Modification Bulletin

20-0033 - MB - EUR - YT - CAM0187 air intake damper and aftertreatment cover (DOT only)

Air intake damper and aftertreatment cover YT193 DOT

figure 1, noise damper on engine (old design)

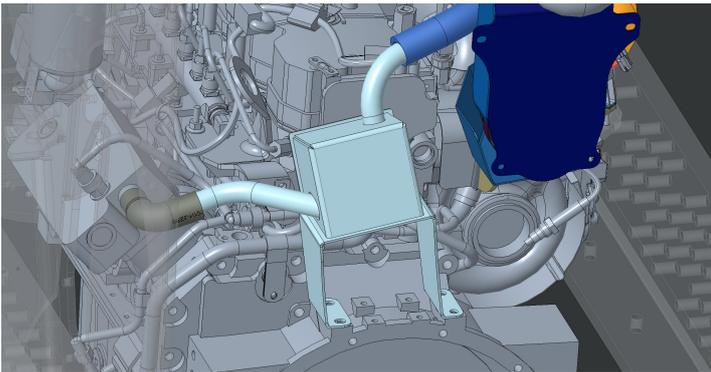
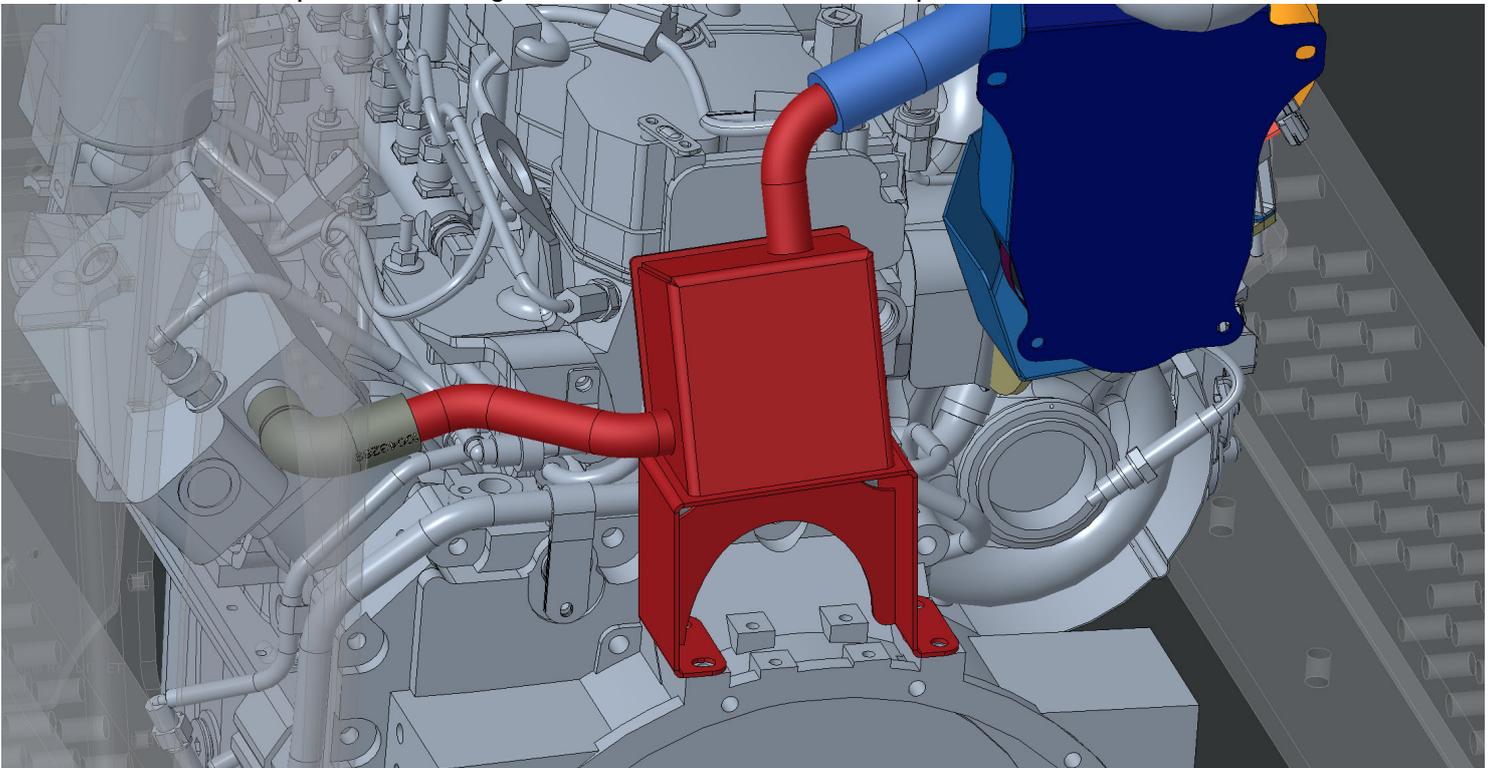
- **Aftertreatment System Cover:** The shape of the cover has been redesigned to prevent contact with the air inlet.
- **Air Intake Noise Damper:** The damper on the compressor air intake has been reinforced to better withstand vibrations and improve durability.

Some vehicles were already equipped with the improved noise damper during production. Therefore, the attached VIN list includes a column indicating whether the noise damper requires replacement for each specific vehicle.

1. Park the vehicle in a safe place, apply park brake and switch engine off.
2. Tilt the cabin fully.
3. Remove the hoses that connect tot the air intake damper.
4. Reomove the bolts that connect the damper to engine housing.
5. Install new damper, re-use flange bolts M8x20, t29064192. Torque these bolts to 25Nm.

6. Re-install the hoses tot he air intake damper.
7. Finish work under the cab and lower cabin.

figure 4, intake hose t10112217

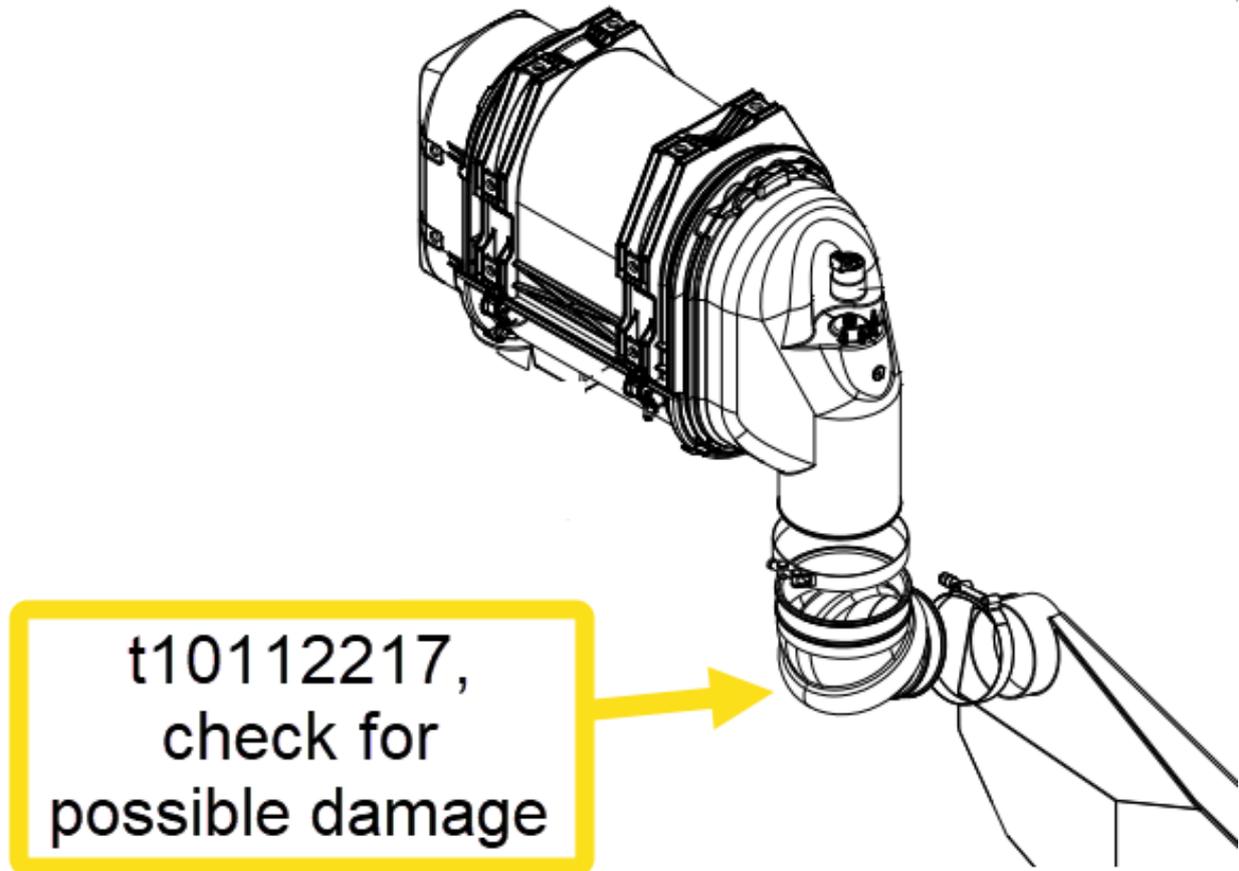
8. Remove the cover t24126568 from the exhaust/aftertreatment cover.
9. Check if the cover has been wearing on the air intake hose t10112217. Replace this intake hose when visibly worn due to contact with the cover. See figure 4.
